ADDENDUM No.3

HERITAGE HIGH SCHOOL

CITY OF LYNCHBURG BID NO.: 14-896
LYNCHBURG CITY SCHOOLS C.I.P. NO.: YS032
3020 WARDS FERRY ROAD
LYNCHBURG, VIRGINIA 24502

FEBRUARY 28, 2014

DRAWN BY:	ATTACHMENT TO:	DWG. NO:
JWM		**AD-3**
DATE: *02/24/14*	PROJECT NO: *520910*	**C1.12**

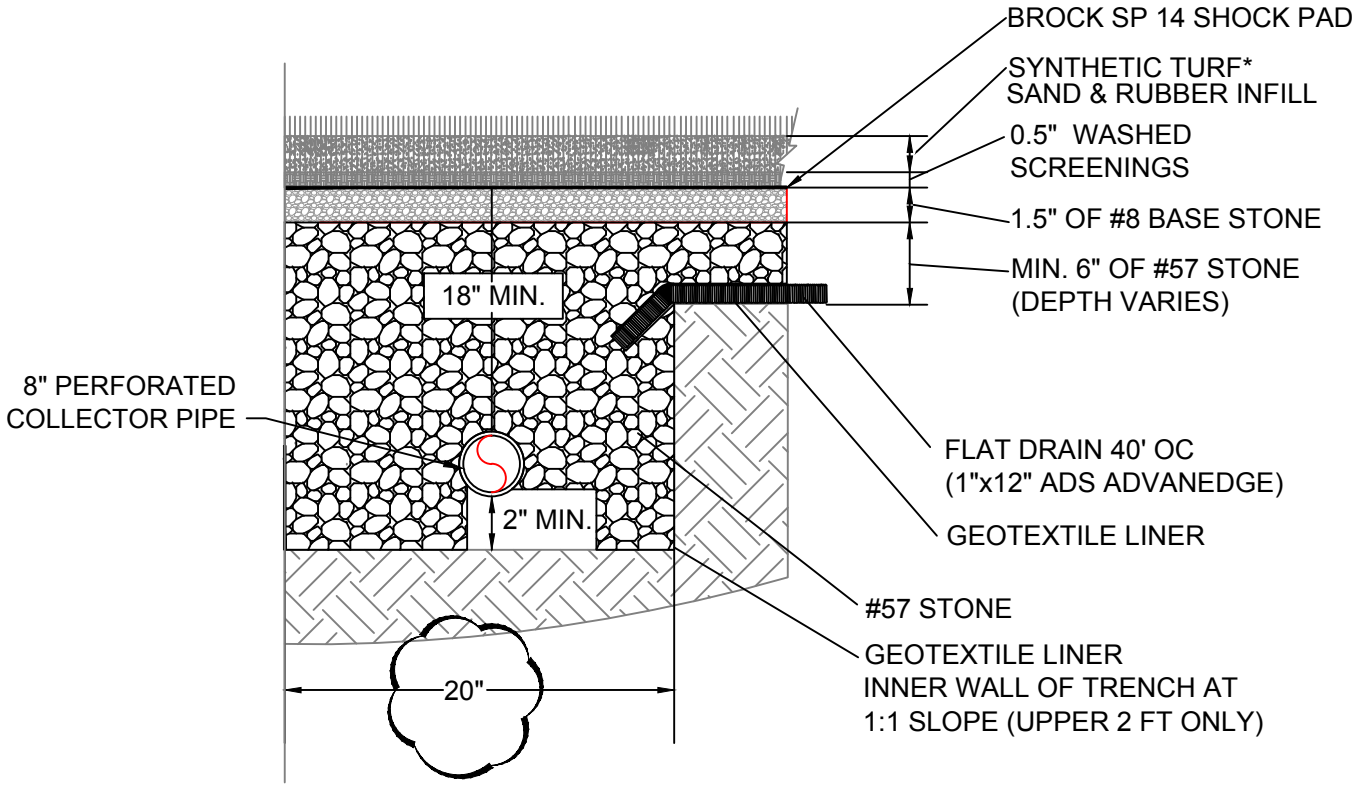
DRAWING C1.12

1. REVISE trench width to 20" at collector pipe. Refer to sketch AD-3 C1.12.

DRAWN BY:	ATTACHMENT TO:	DWG. NO:
JWM		**AD-3 C2.02**
DATE: *02/24/14*	PROJECT NO: *520910*

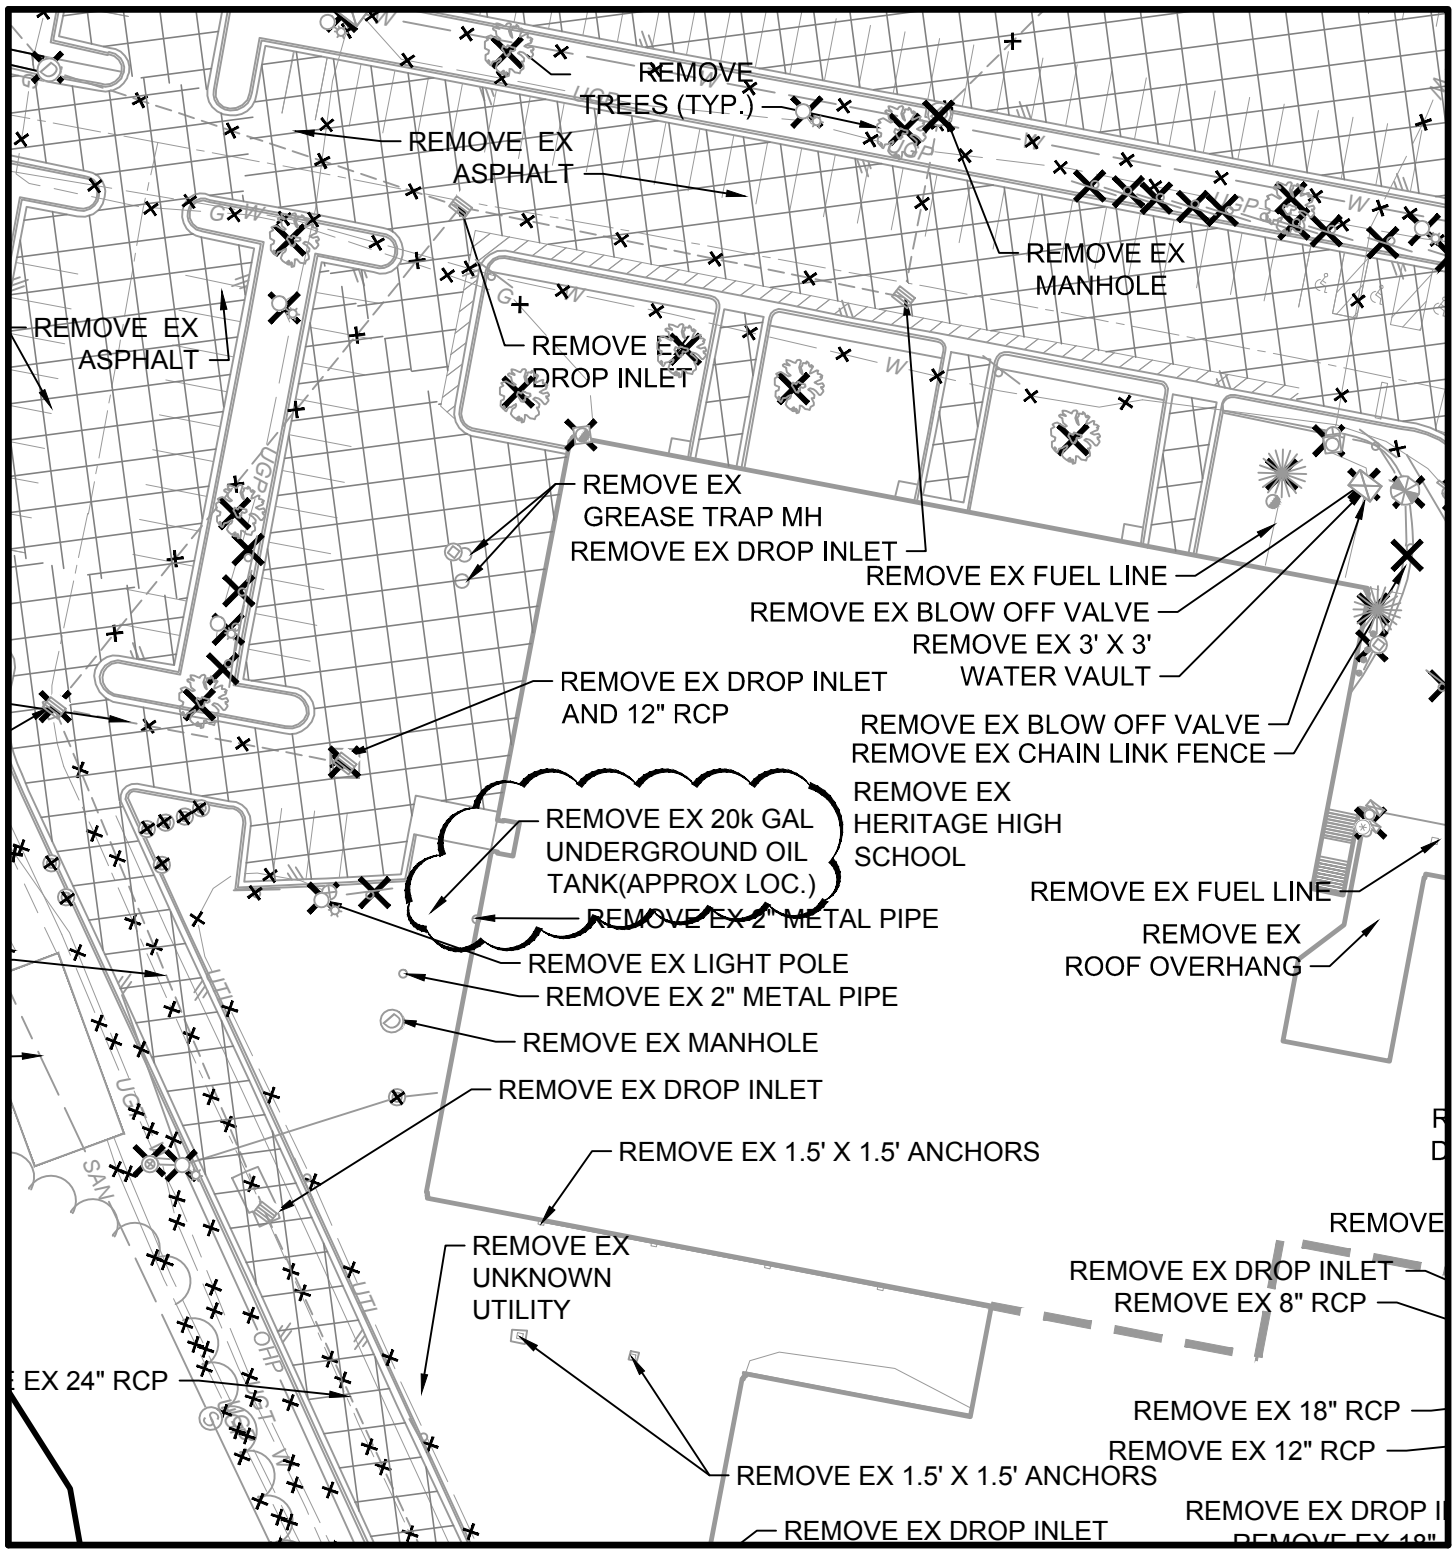
DRAWING C2.02

1. ADD callout to remove existing underground oil tank & any remaining fuel per local & national standards. Refer to sketch AD-3 C2.02.

DRAWN BY:	ATTACHMENT TO:	DWG. NO:
JWM		**AD-3**
DATE:	PROJECT NO:	**C3.3**
02/24/14	*520910*

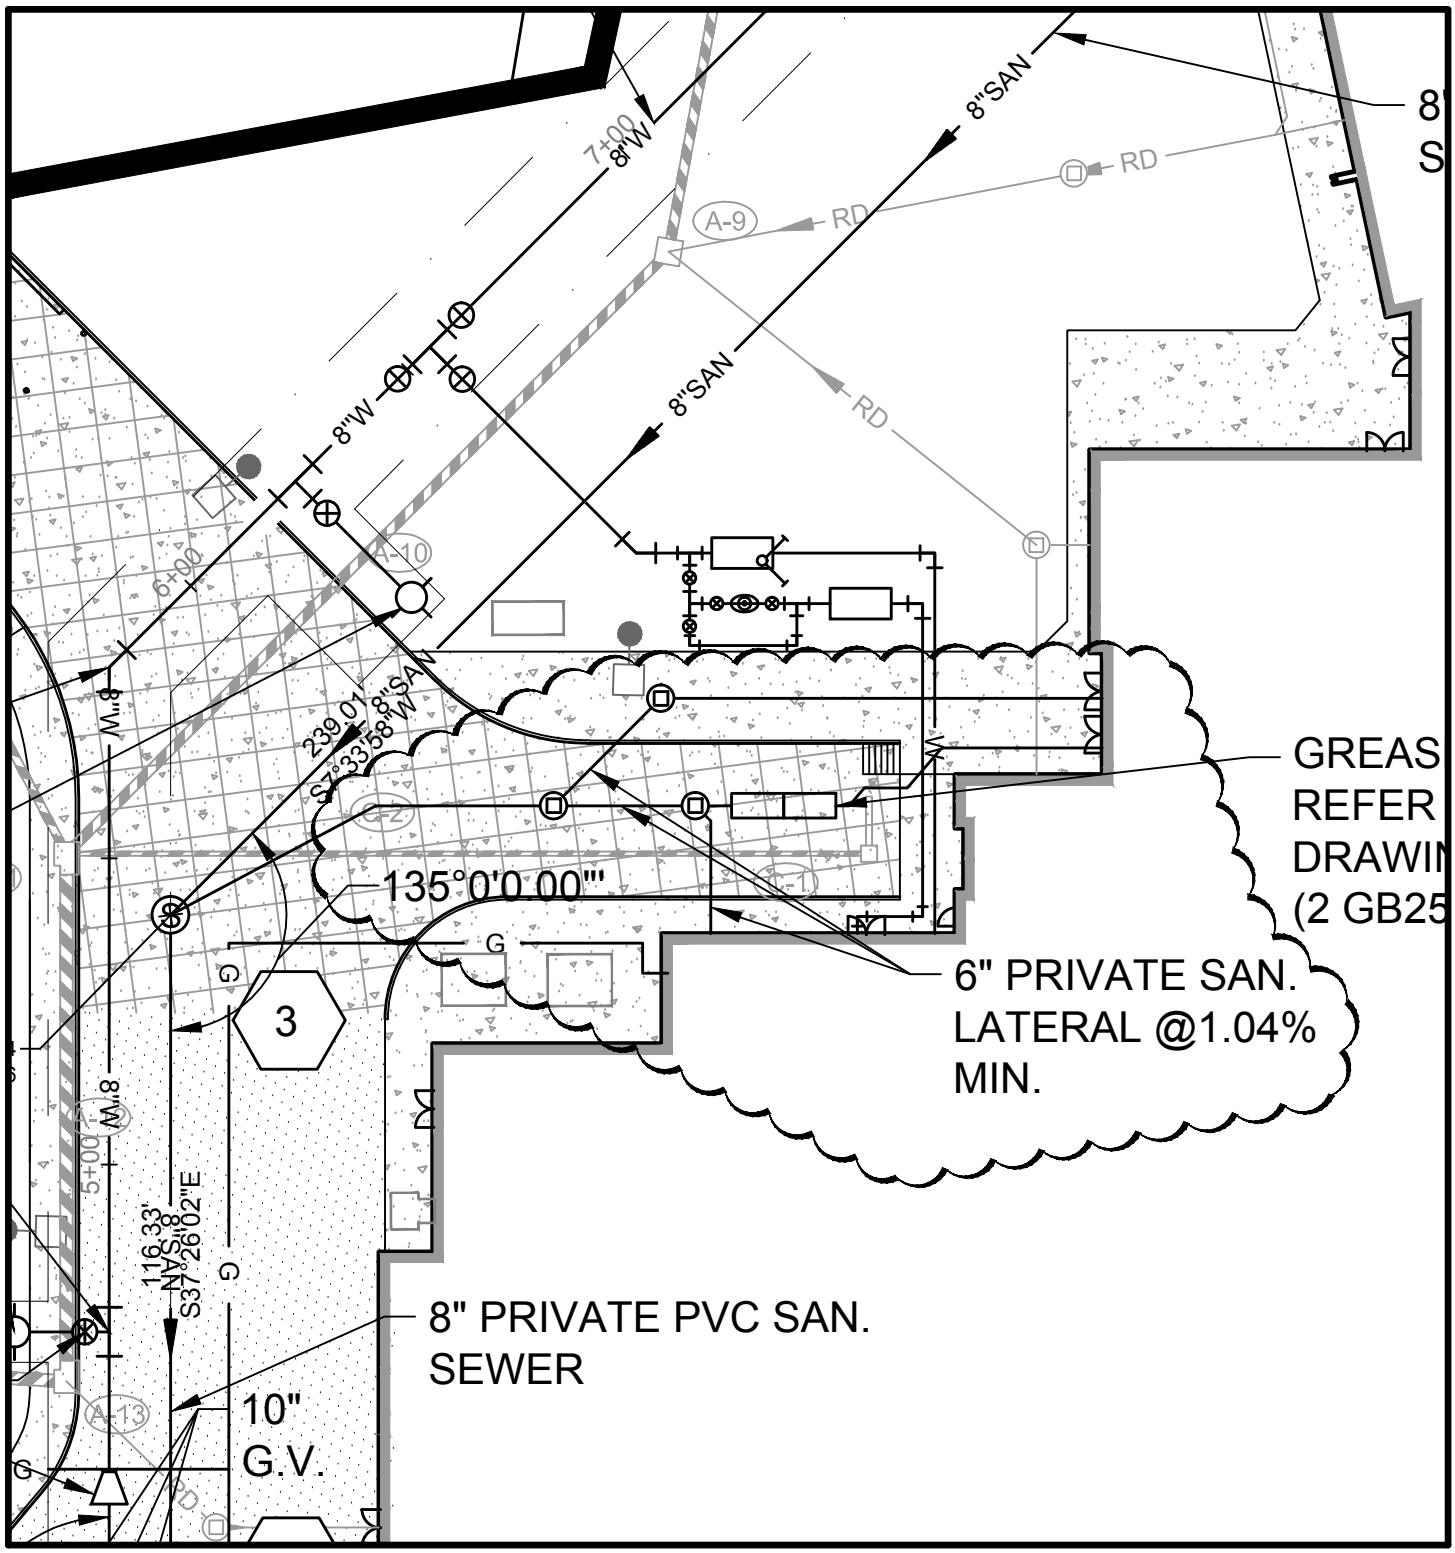
DRAWING C3.3

1. REVISE layout of sanitary laterals in the area of the loading dock. Refer to sketch AD-3 C3.3.

DRAWN BY:	ATTACHMENT TO:	DWG. NO:
JWM		**AD-3**
DATE:	PROJECT NO:	**C4.0**
02/24/14	*520910*

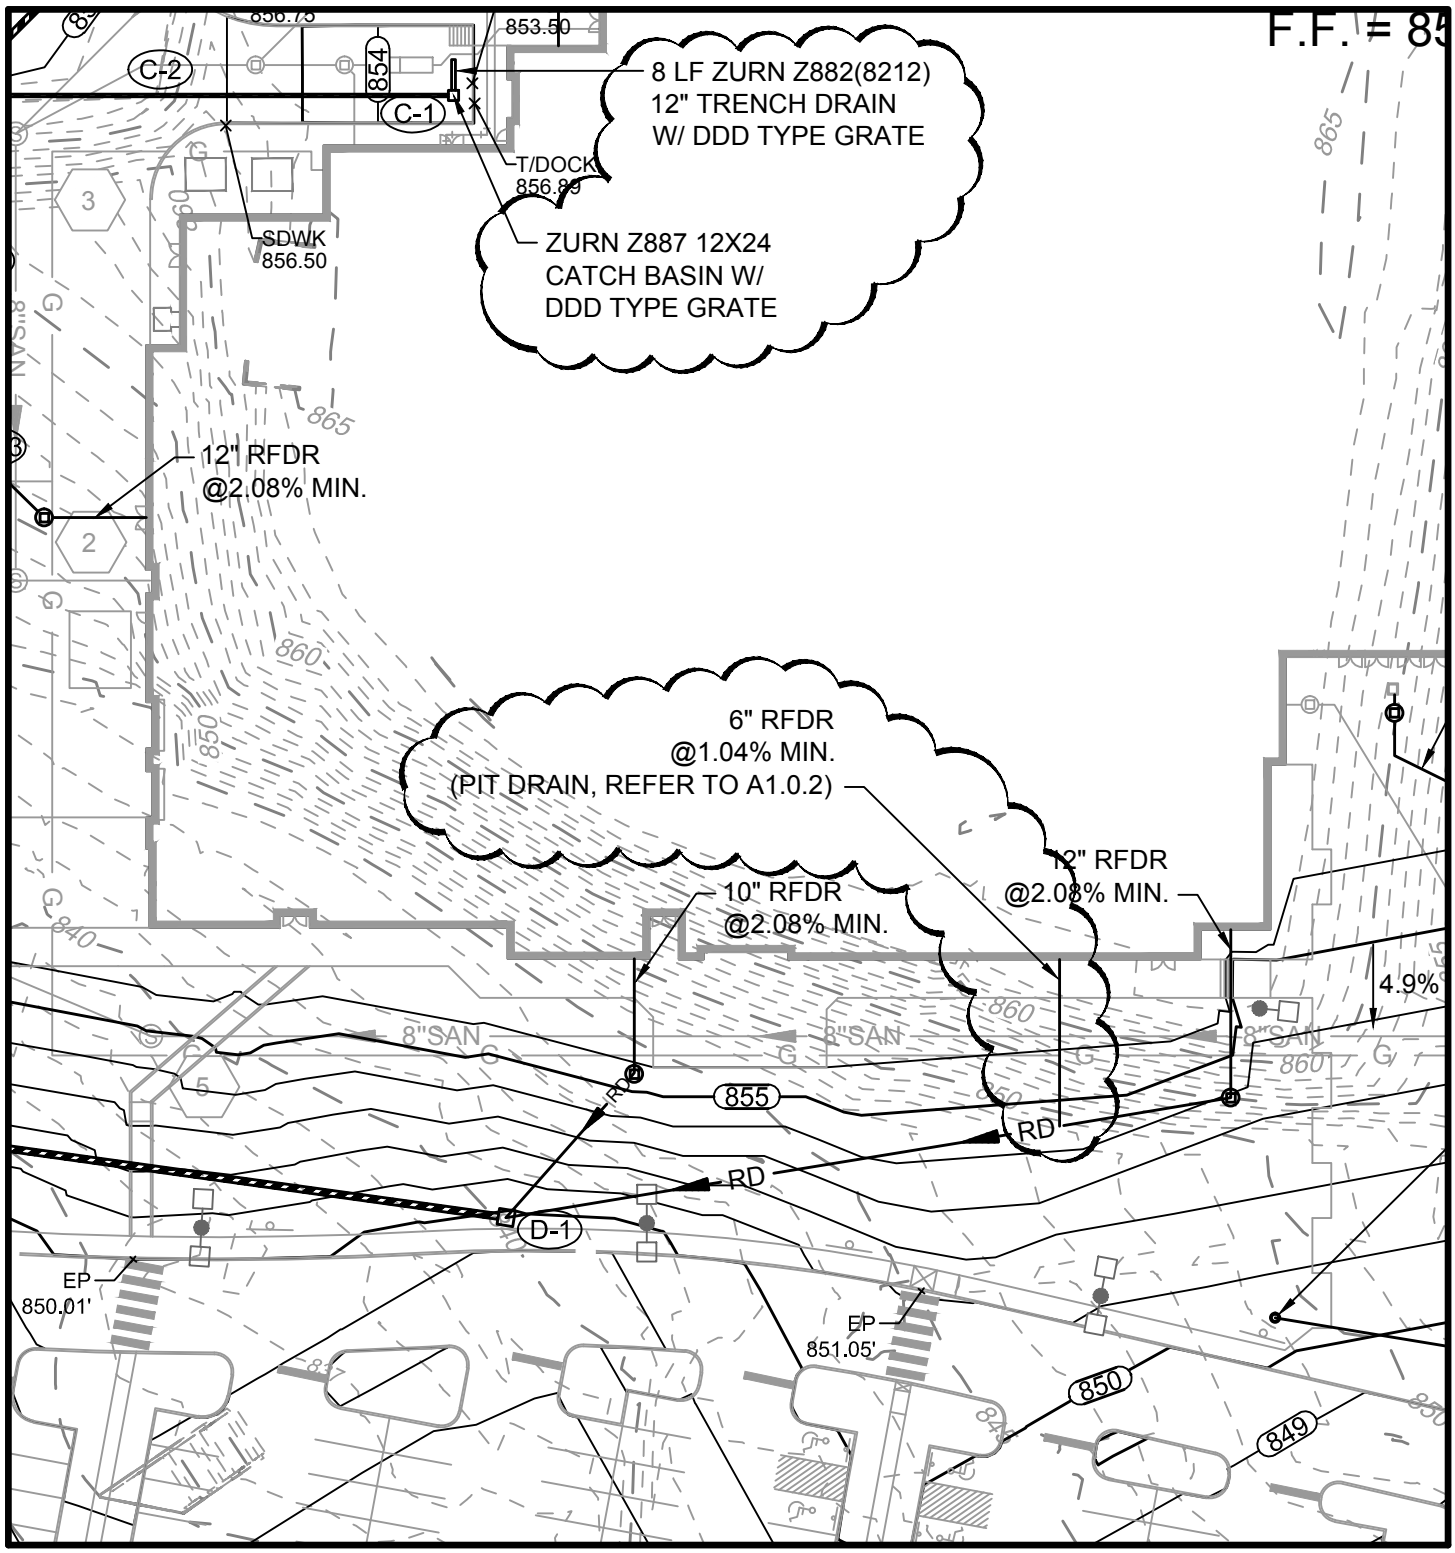
DRAWING C4.0

1. ADD callout for interior pit drain. REVISE callouts for loading dock trench drains Refer to sketch AD-3 C4.0.

DRAWN BY:	ATTACHMENT TO:	DWG. NO:
MMP		**AD-3**
DATE:	PROJECT NO:	**L1.4**
02/26/14	*520910*

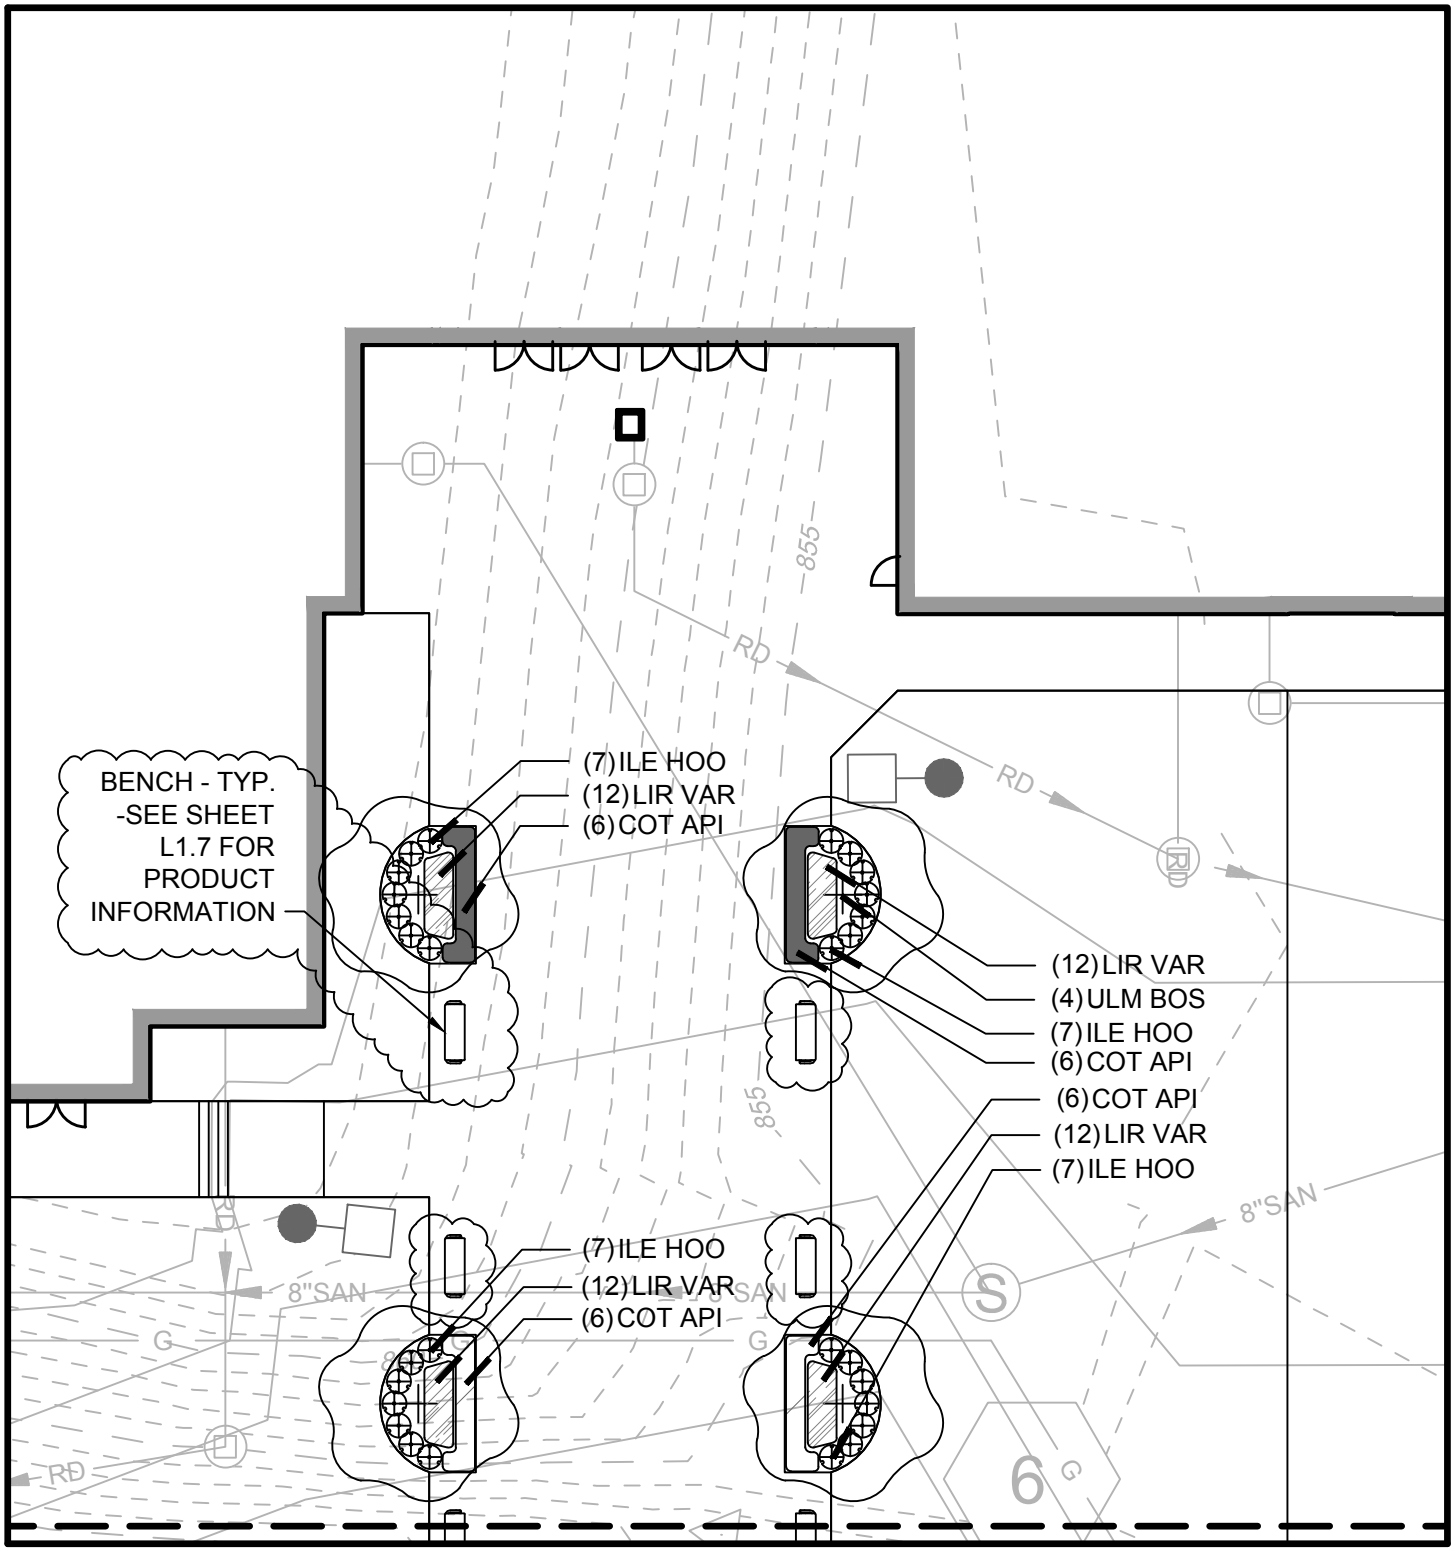
DRAWING L1.4 & L1.7

1. ADD callout for benches at student entrance. Refer to sketches AD-3 L1.4 & AD-3 L1.7.
